Site Accessibility Evaluation

SEATS and Secondary Roads

**4810 Melrose Ave
Iowa City, IA 52246**

ADA Only

Finding: 7

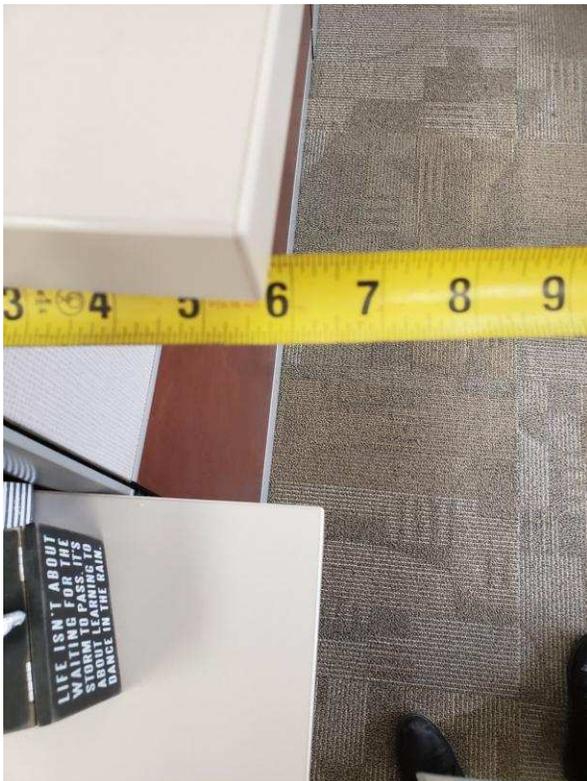
The reception counter projects more than 4 inches into the circulation path.

reception counter
protrudes 5"

Relocate protruding objects or place cane detectable warning or bollard at foot of item

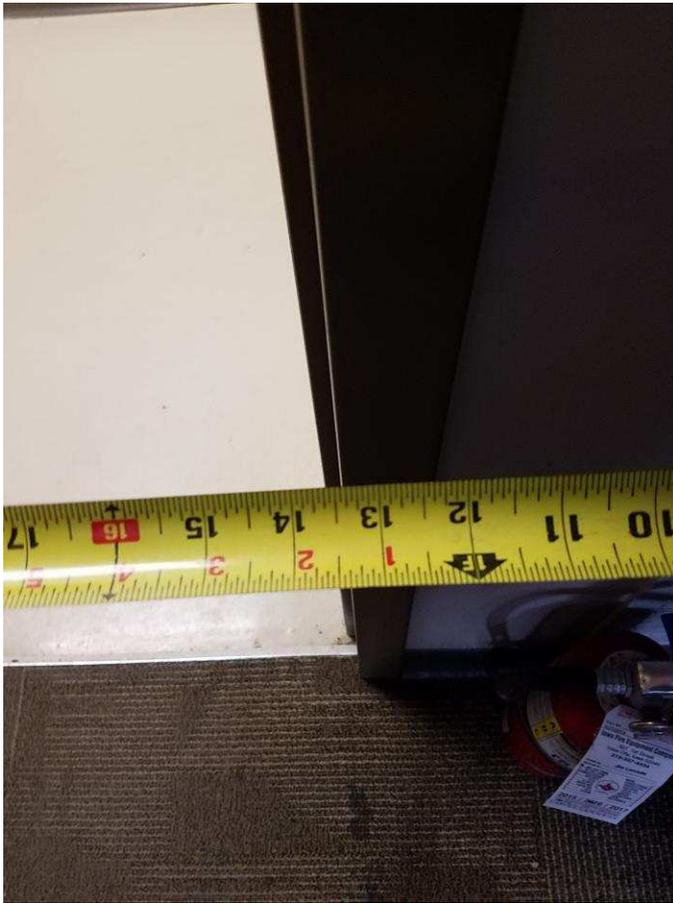
Rm 123 - 47.5" to
window, desk at 13.5"
on pull, 14#

For all doors along the public circulation route, provide required maneuvering clearance on push and pull side of doors

For all doors along the public circulation route, replace doors with ones having sidelight viewing windows max 43" aff

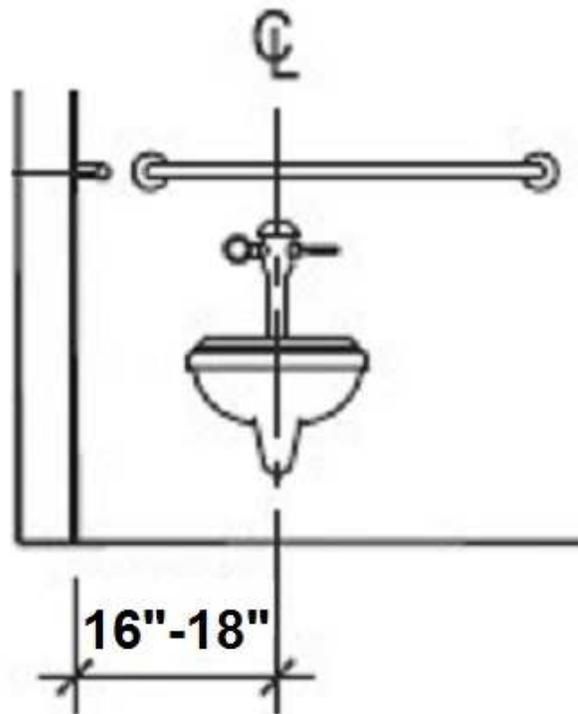
centerline 18.5"

Remount toilets to 16" to 18" from the side wall to centerline

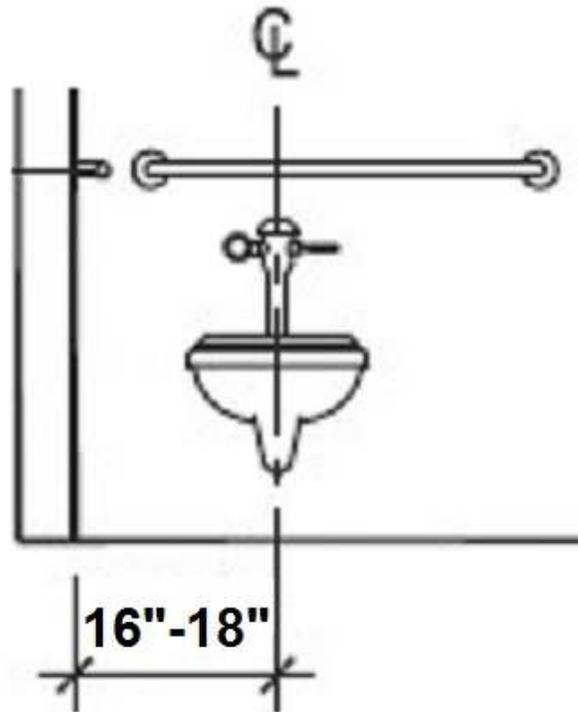
centerline 19.5"

Remount toilets to 16" to 18" from the side wall to centerline

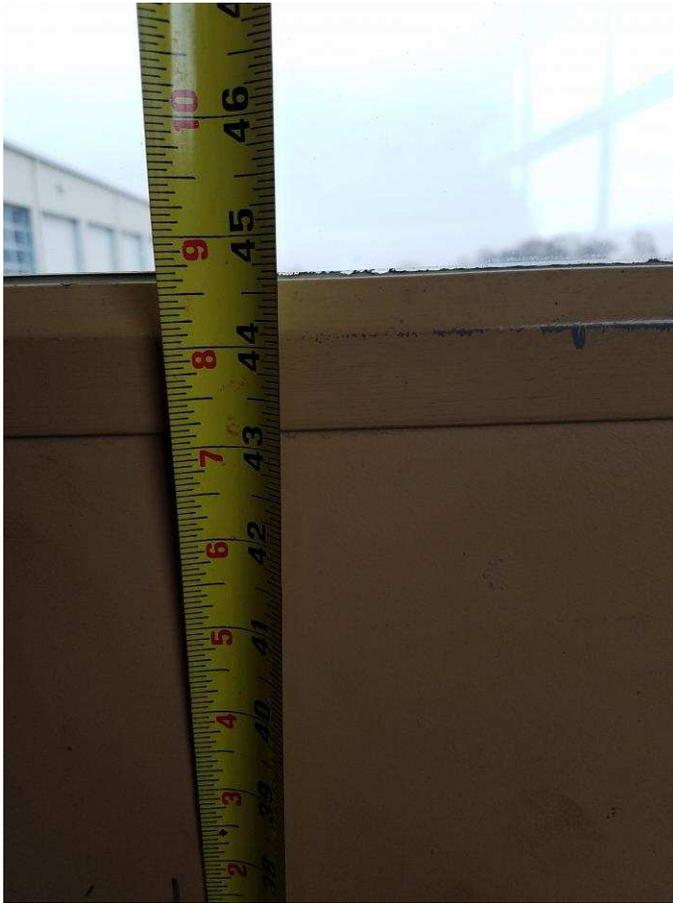
N2 entry - 11#, fast,
window 44.5"

For all doors along the public circulation route, inspect, adjust, and maintain 5 lbf to open interior doors

For all doors along the public circulation route, replace doors with ones having sidelight viewing windows max 43" aff

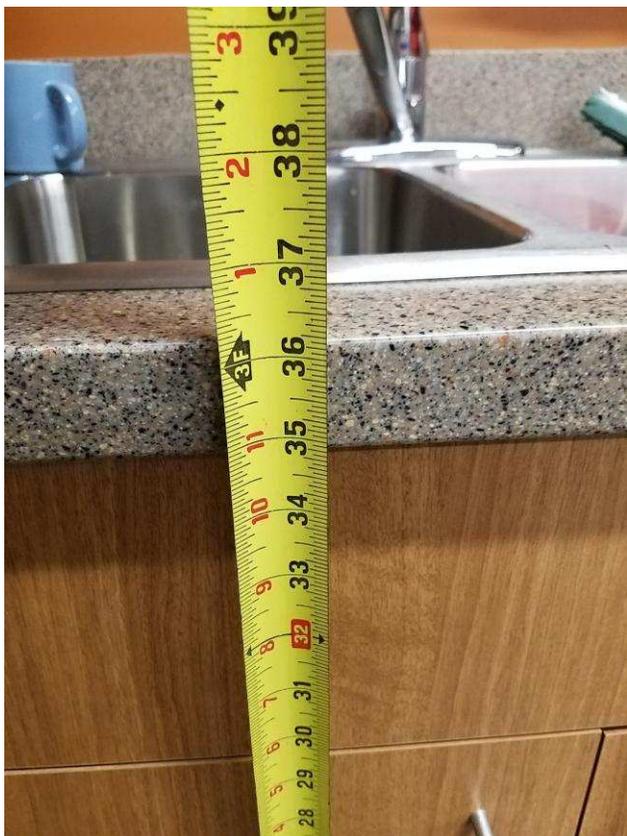
Break room - sink at 36"

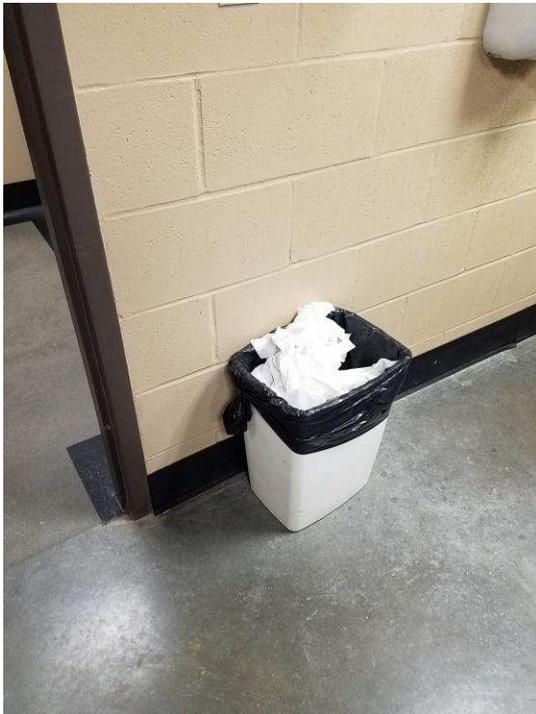
Men's RR - garbage
can on pull, 14#

For all doors along the public circulation route, provide required maneuvering clearance on push and pull side of doors

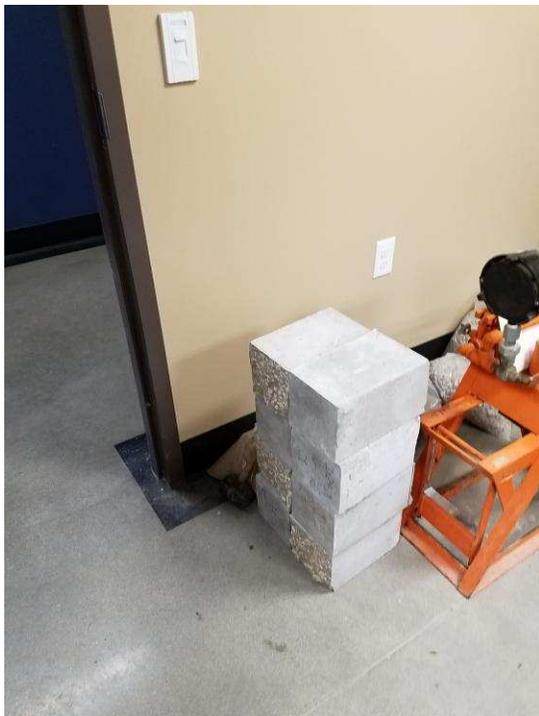
201 Lab - 15#, storage on pull

For all doors along the public circulation route, provide required maneuvering clearance on push and pull side of doors

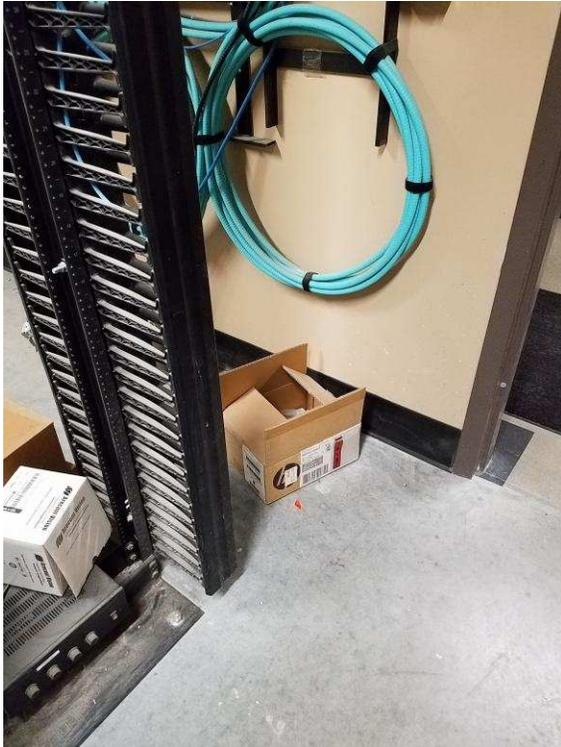
216 Utility - 16#, IT
tower on pull

Leave as is maneuvering clearance, infeasible to correct
